ADDENDUM #1
March 05, 2019

For
Jordan School District
West Jordan High School
Counseling Center / Day Care Remodel
8136 South 2700 West
South Jordan, Utah 84088

Project: West Jordan Counseling &
Daycare upgrade
Addendum No: 1
Pages: 3

West Jordan High School Counseling Center / Day Care Remodel
 Sheet A7.1, Added Corridor Section Drawing
 Architectural Addendum #1
 5 March 2019

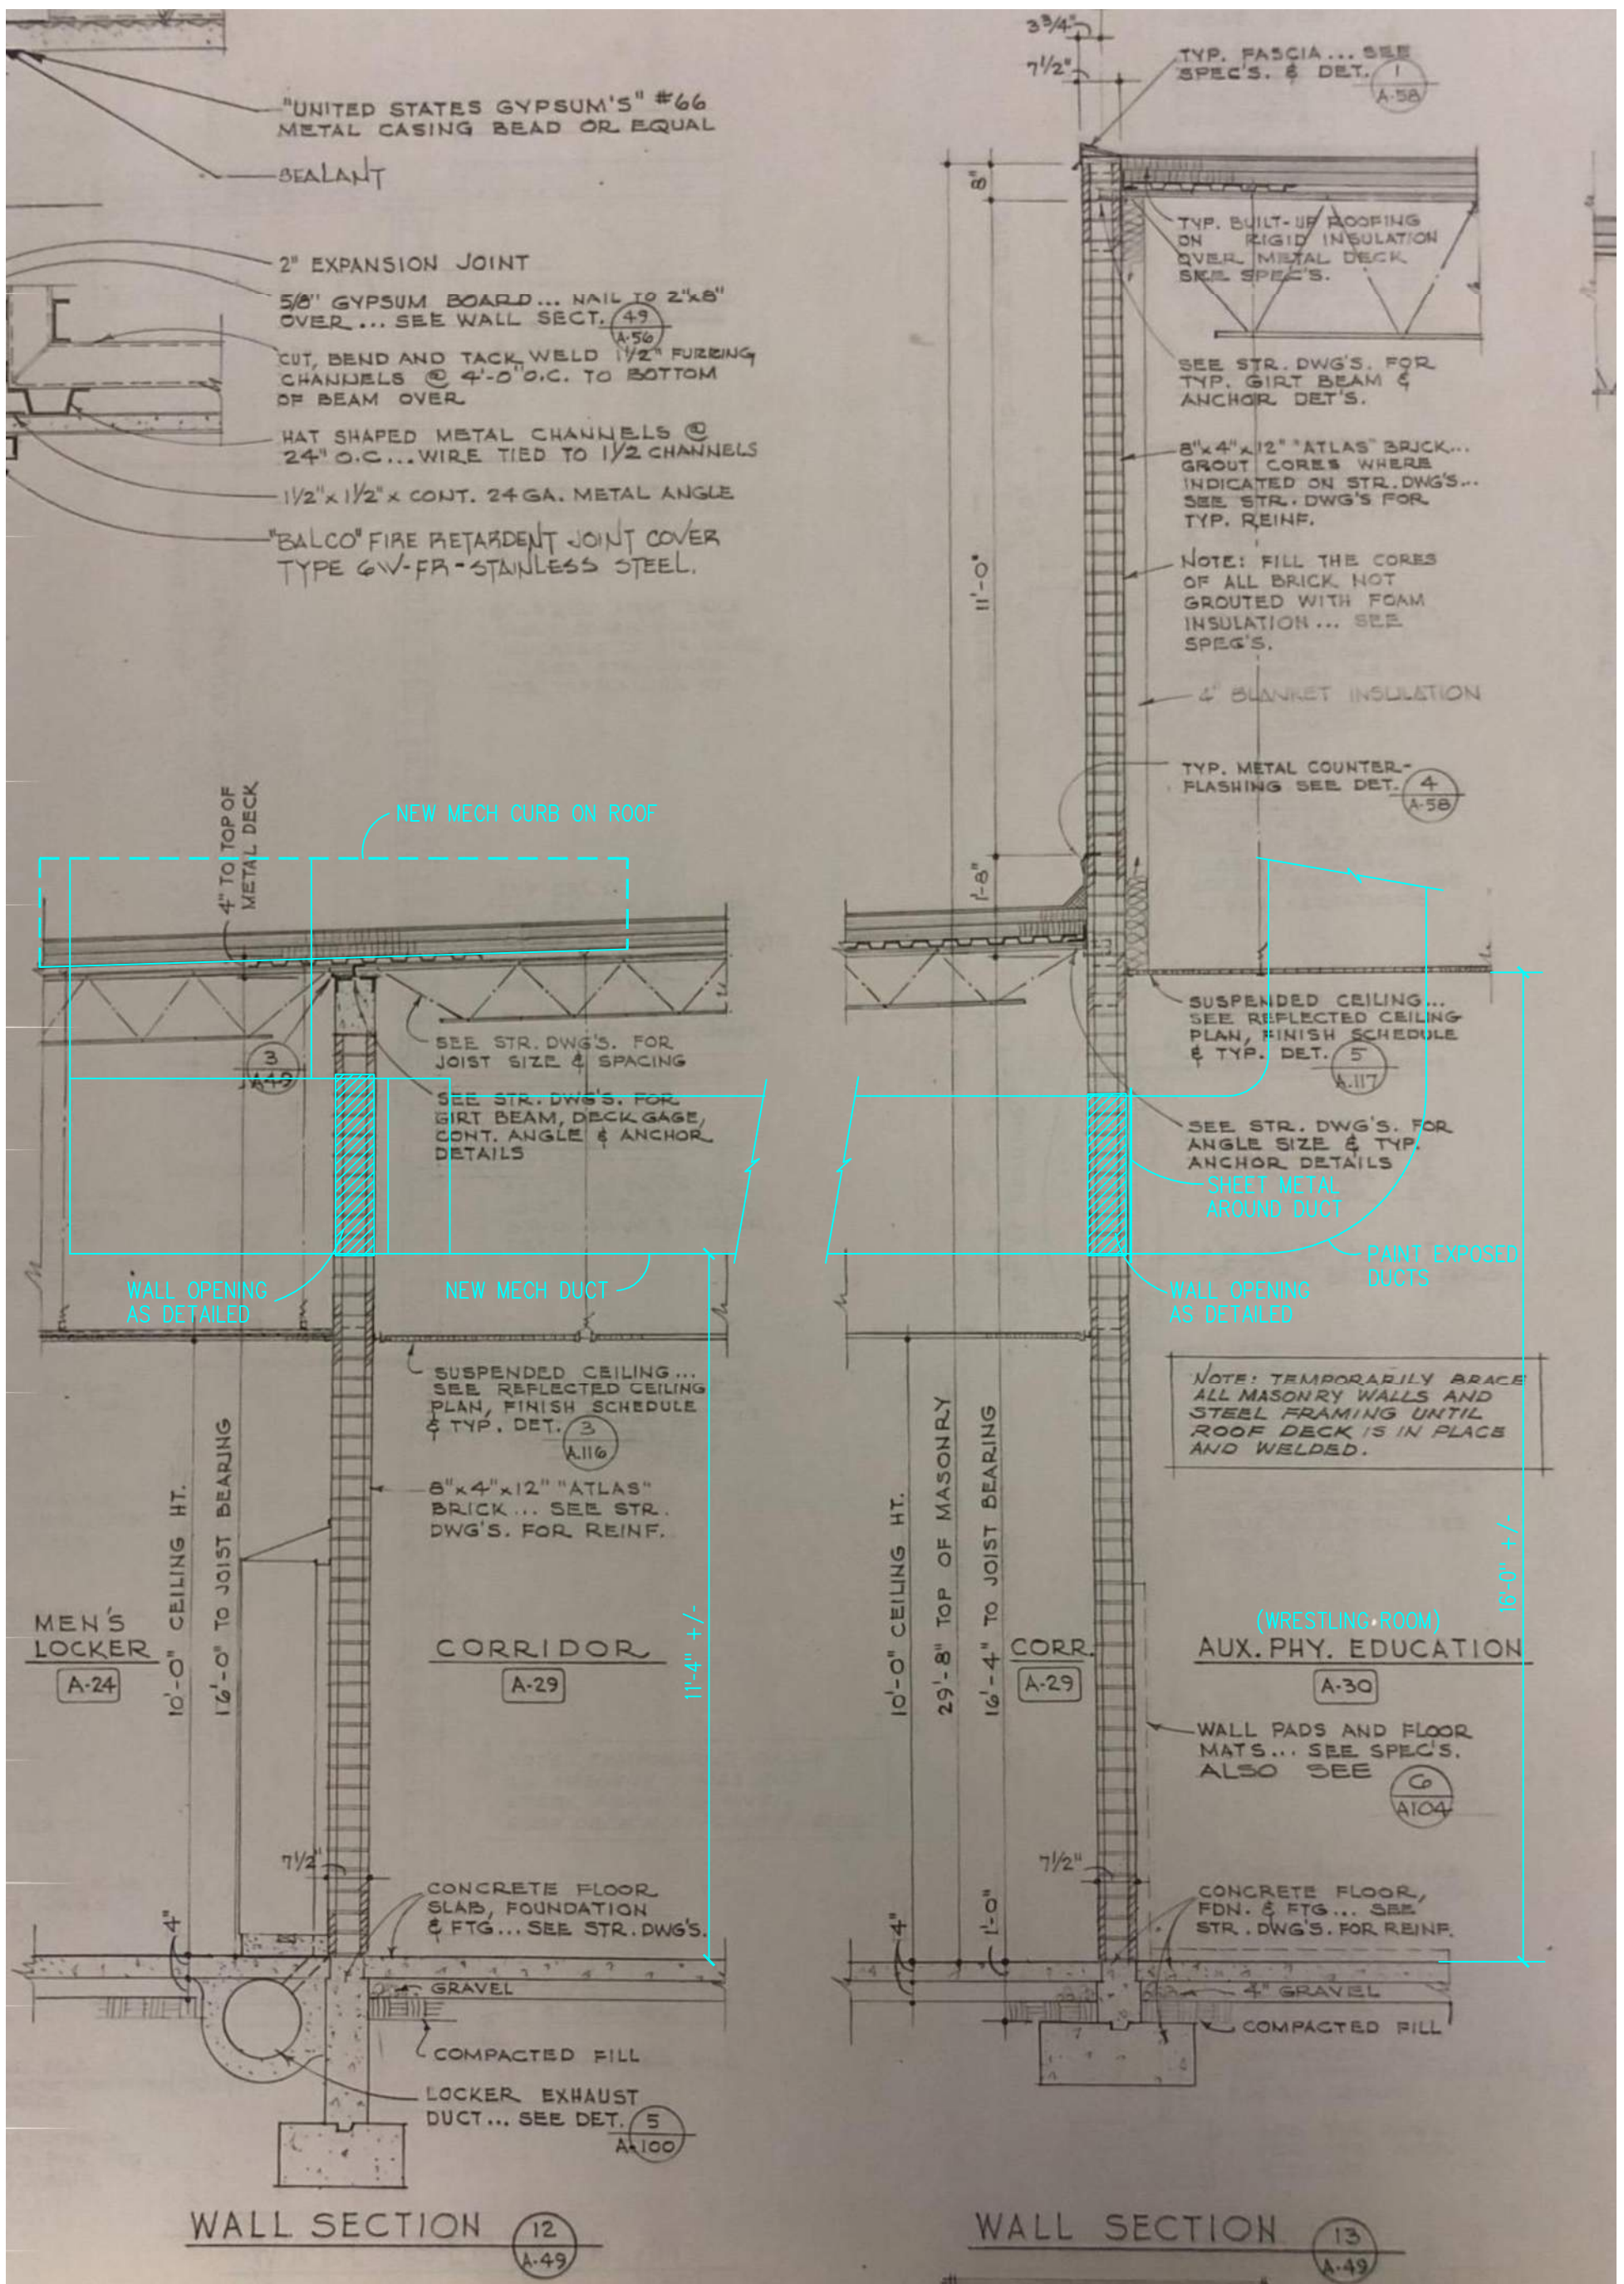
1.01 Refer to the attached add drawing for clarification of the new duct work installation.

M103

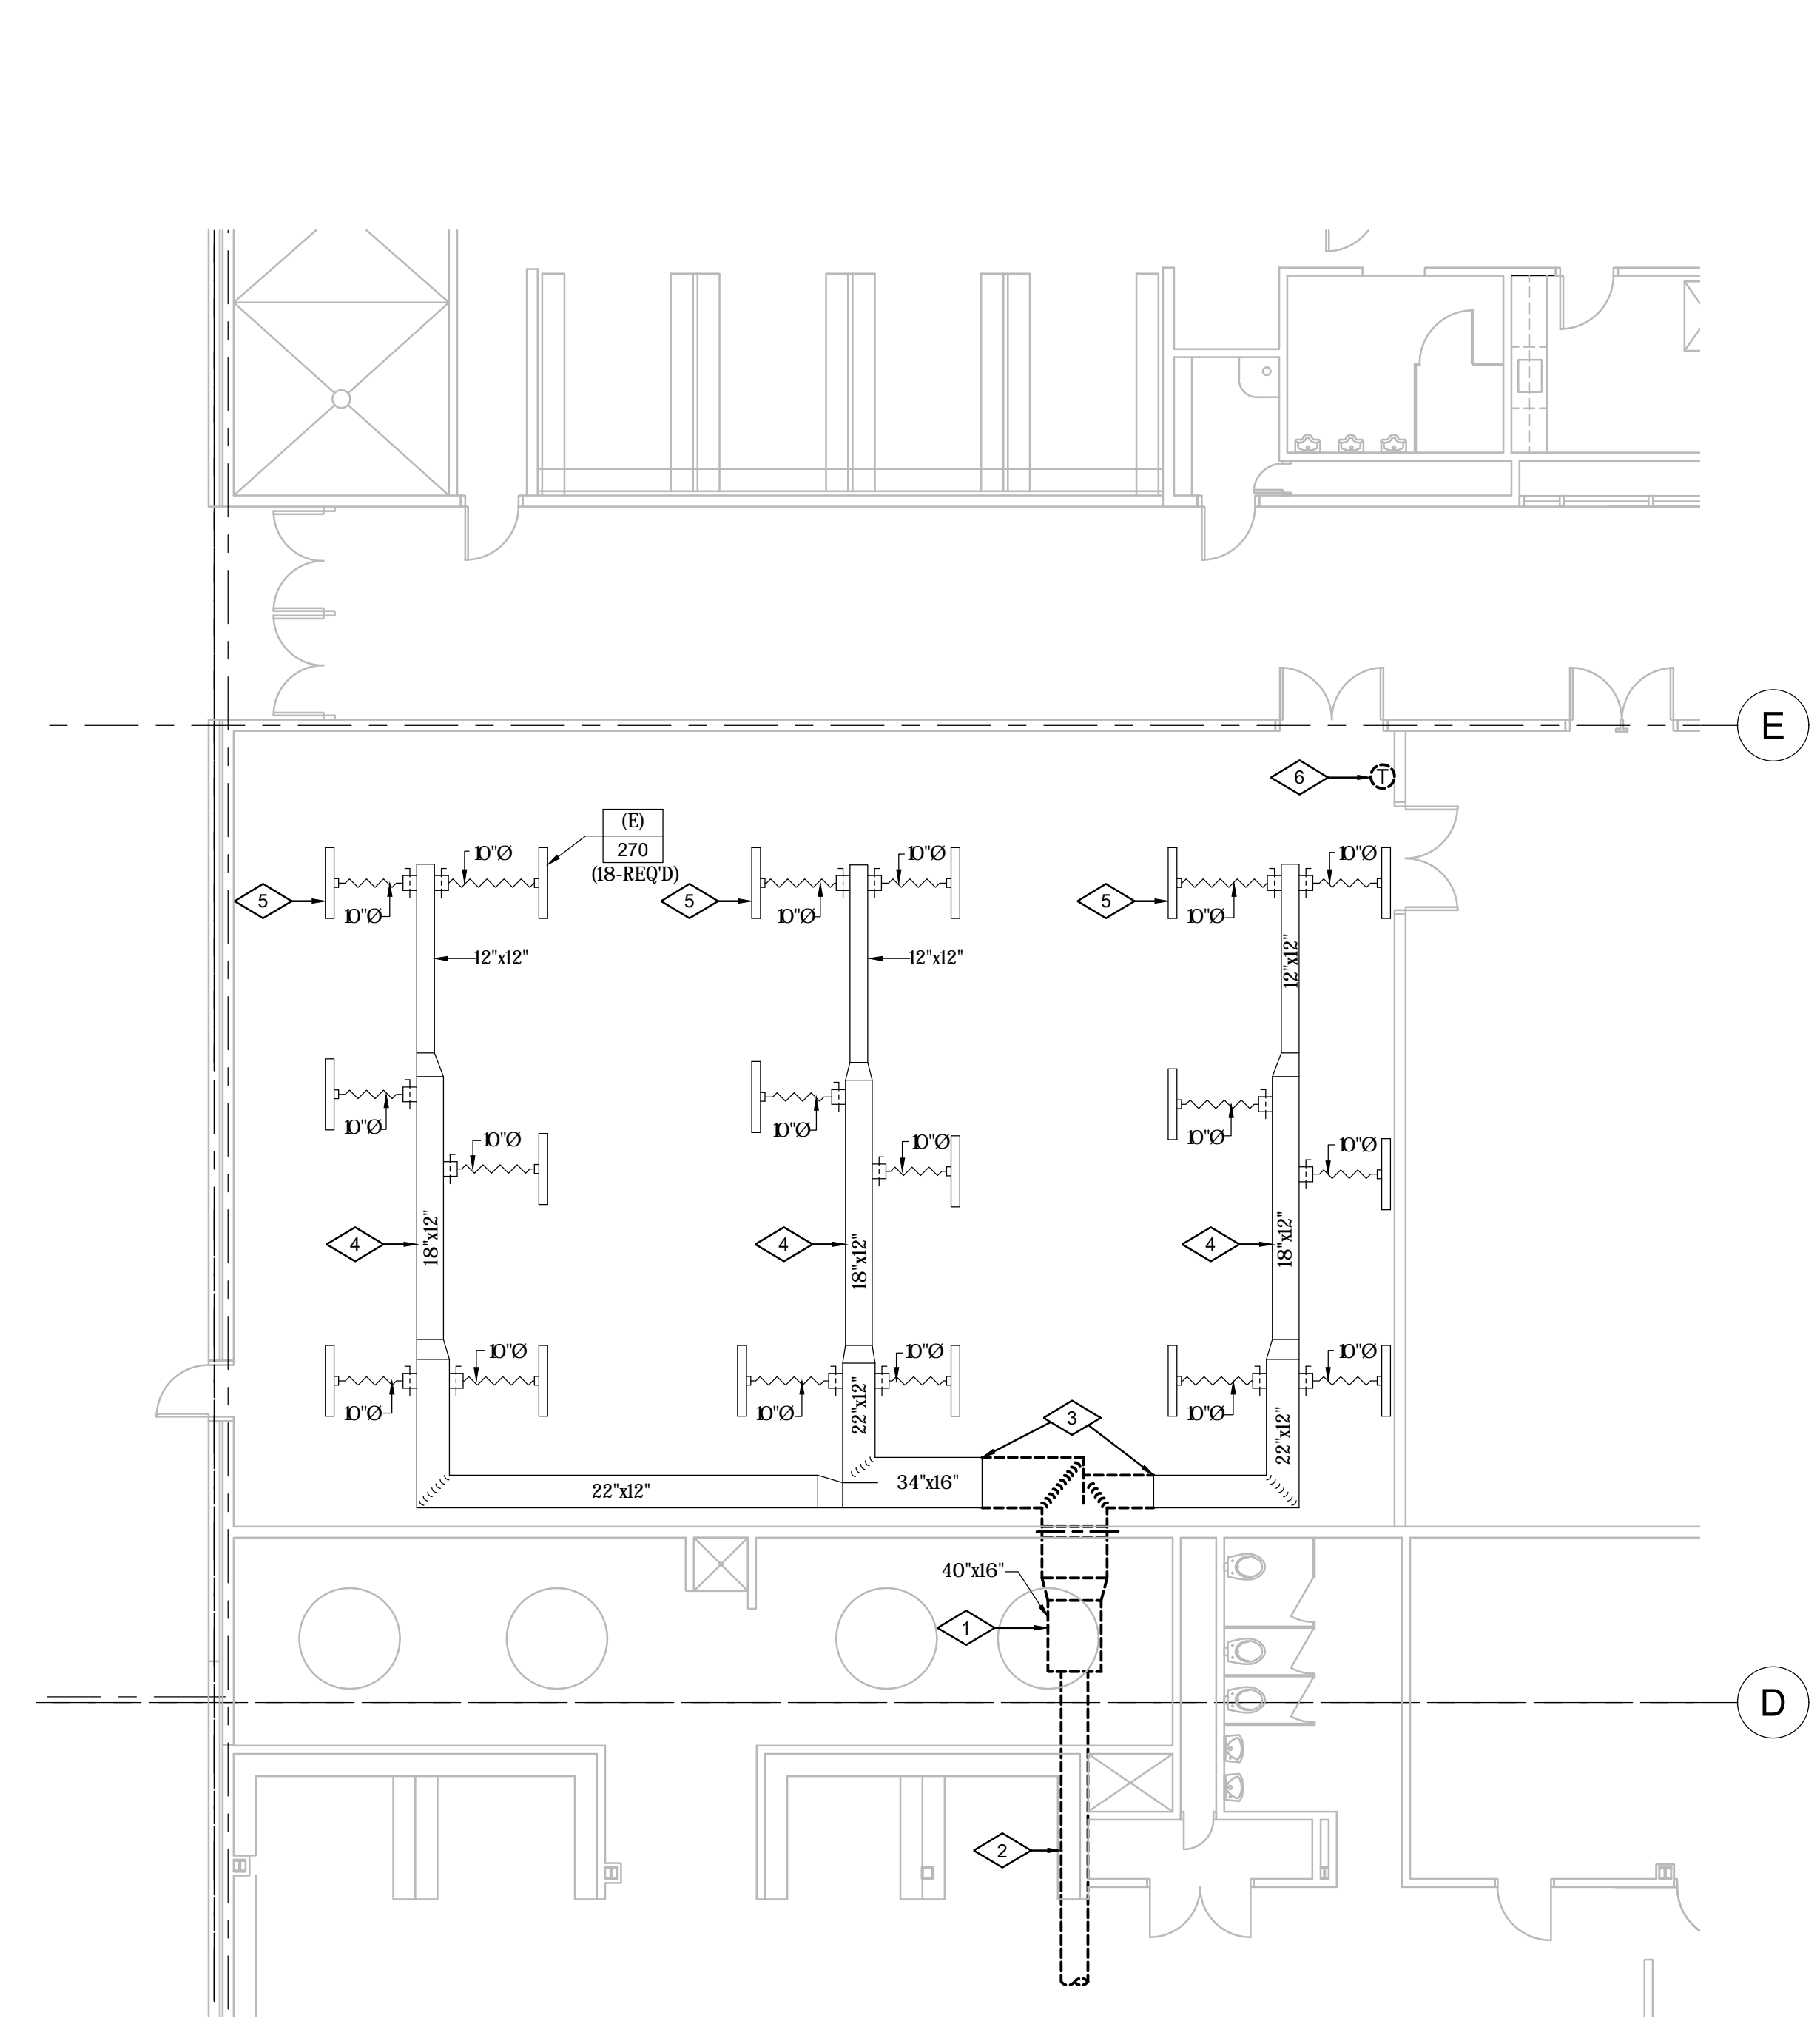
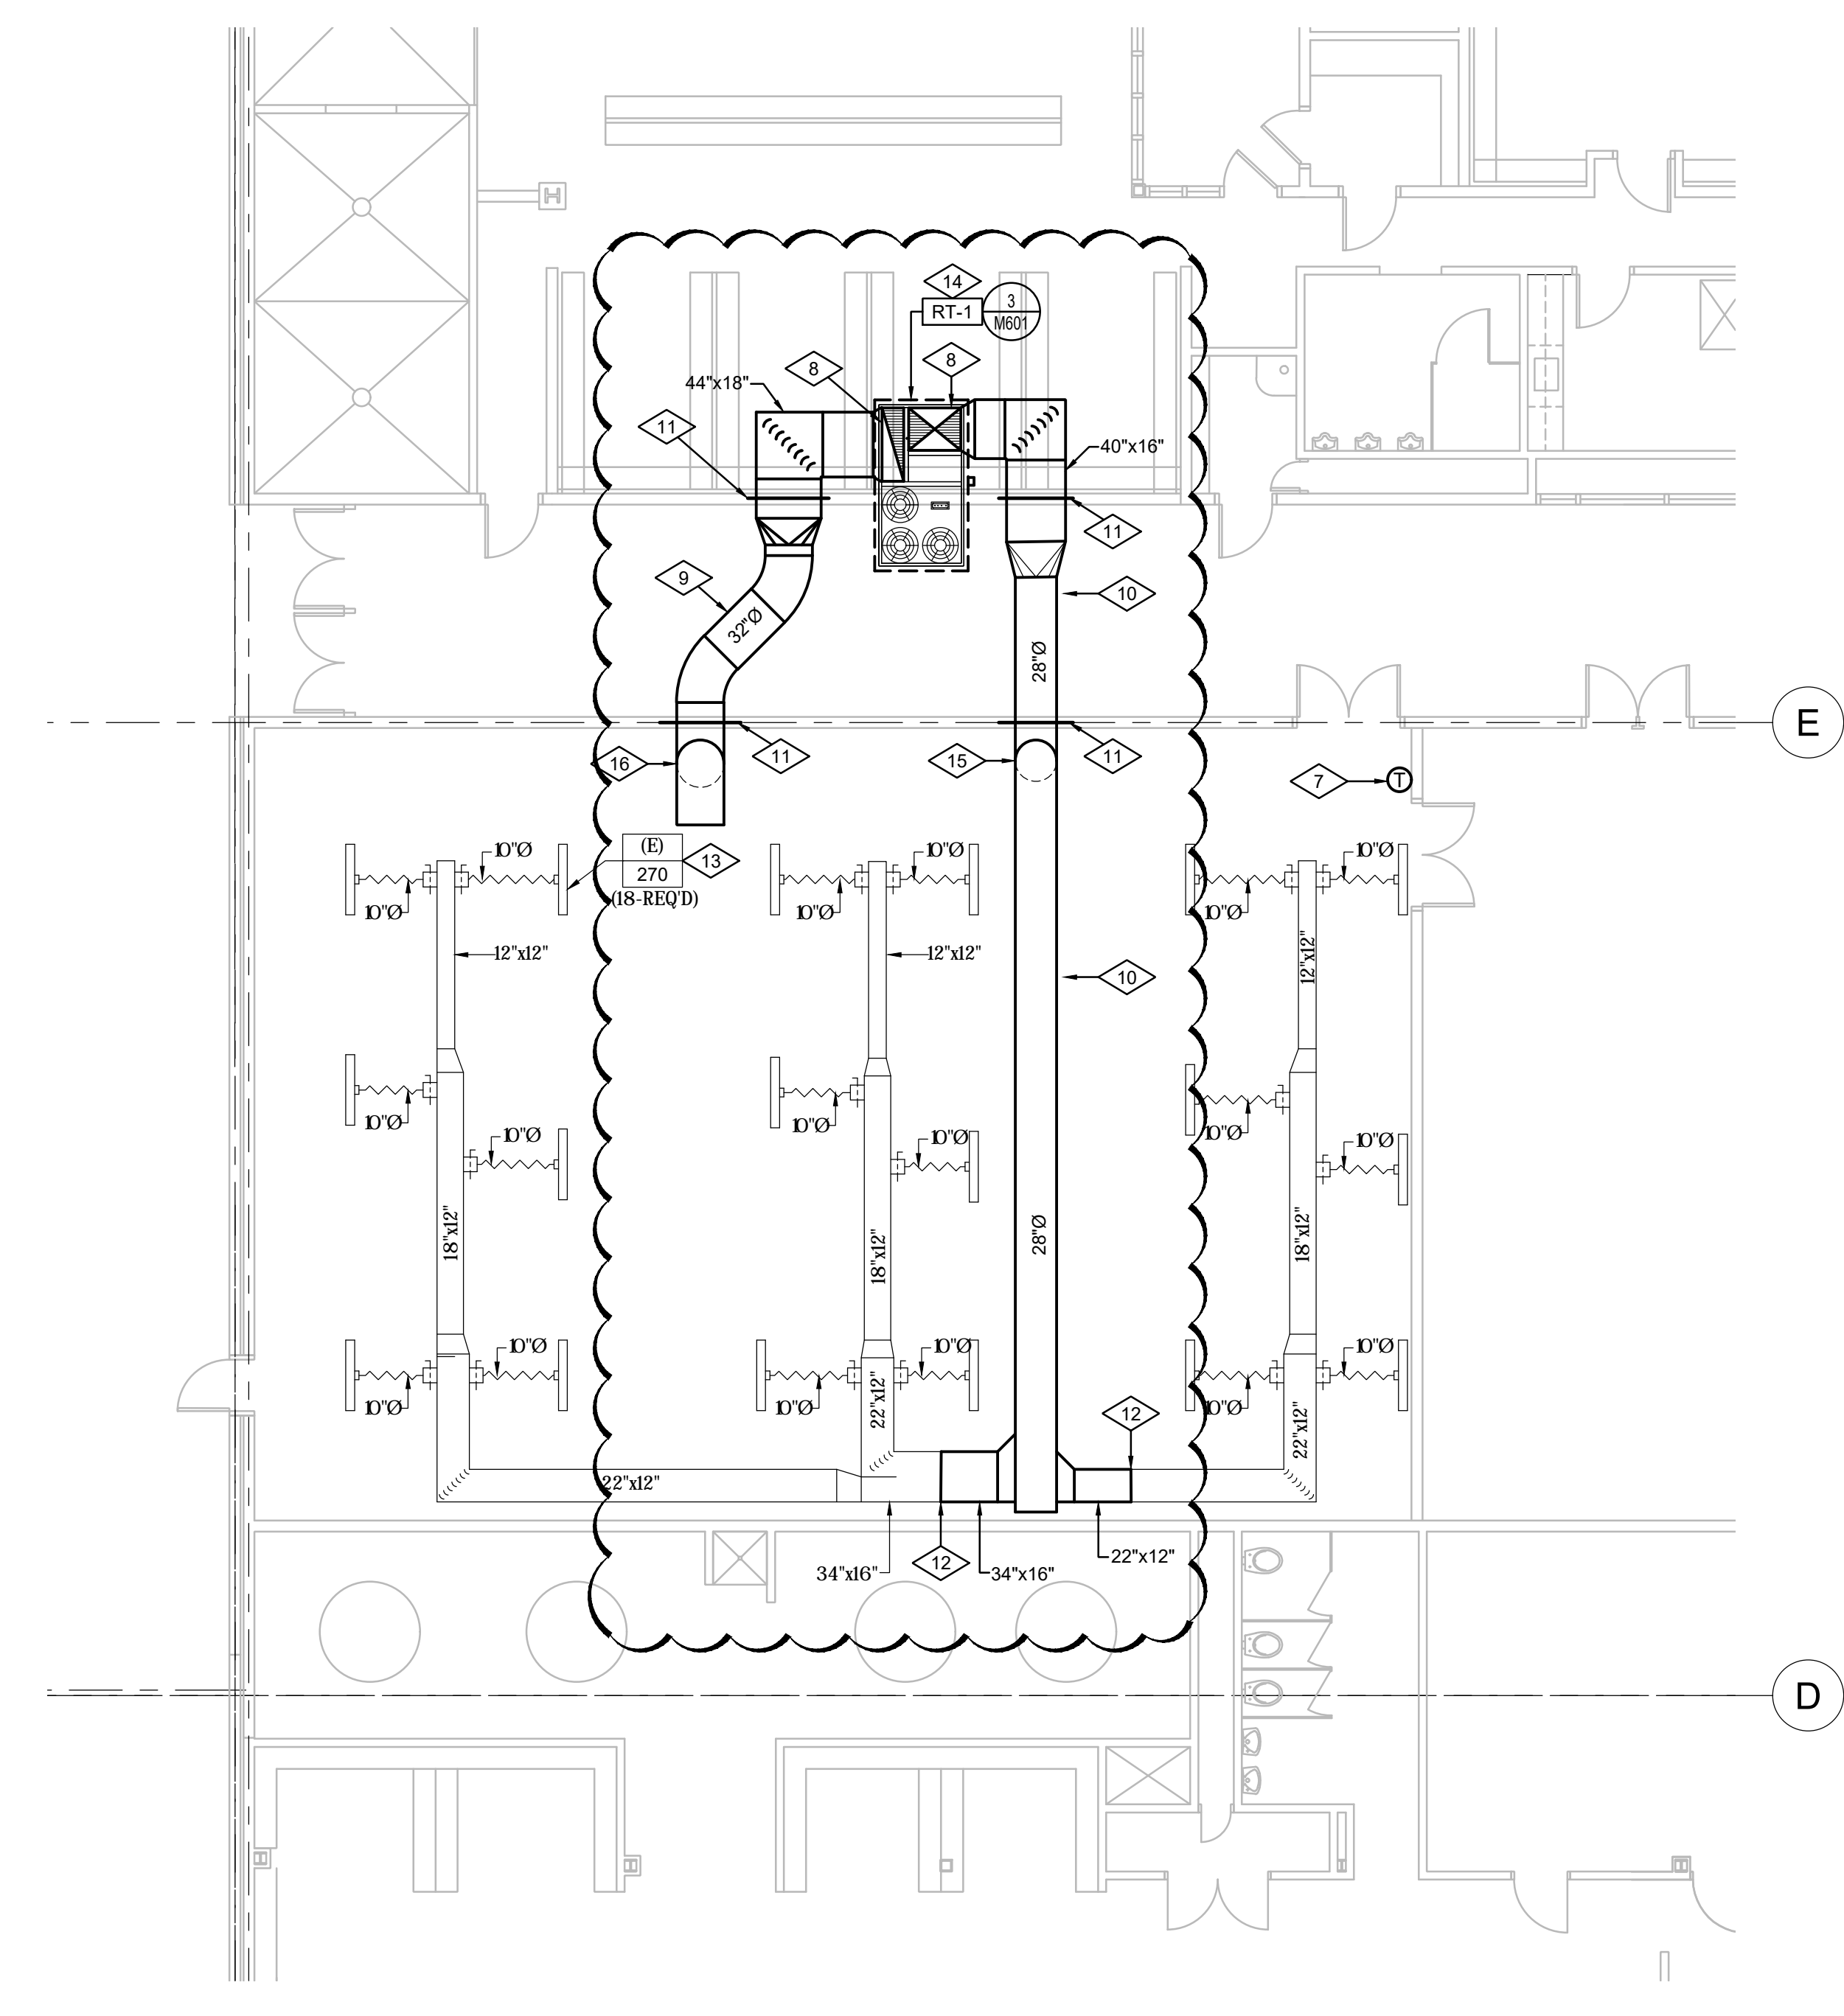
See Attached drawing M103.
